Certified Action Of the City of Raleigh Planning Commission

Case File / Name: S-34-12 / Chamber Court Infill Subdivision

Staff Report

S-34-12 Chamber Court Infill Subdivision – Subdivision Layout

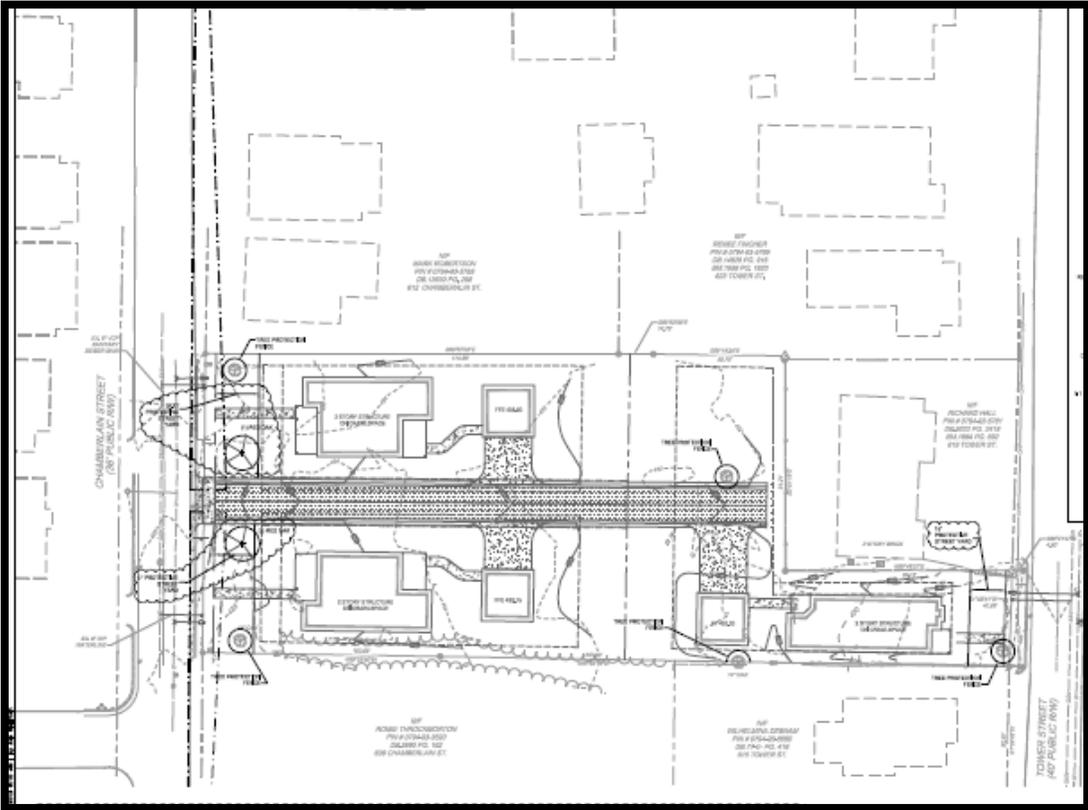
The proposed Lot 3 creates a street frontage of 40.86' which is less than 80% of the median street frontage (42.4') of lots along the periphery of the subdivision.

Proposed lot 3 has an existing road frontage of 40.86'. 80% of the median lot frontage of lots in the periphery is 42.4'.

Proposed lot frontage lot #1	62.25' (117% of median)
Proposed lot frontage lot #2	64.45' (121% of median)
Proposed lot frontage lot #3	40.86' (77% of median)

- (7) That the final site plan for any house to be built on lot 3 show the house positioned in a location between the houses on the two adjoining lots, in conformance with setback standards for the Neighborhood Conservation Overlay District, as shown on the preliminary plan.

VARIANCES / ALTERNATES: A minimum of 40.75' is required for the lot width, per A-81-12 – The BOA granted a 9.25 foot variance in the minimum 50 foot width for a lot to build a new dwelling in the Residential-10 zoning district with Oberlin Village Neighborhood Conservation Overlay District.

A-81-12 – Granted Lot 3 a 9.25 foot variance in the minimum 50 foot width for a lot within the Oberlin Village Neighborhood Conservation Overlay District.
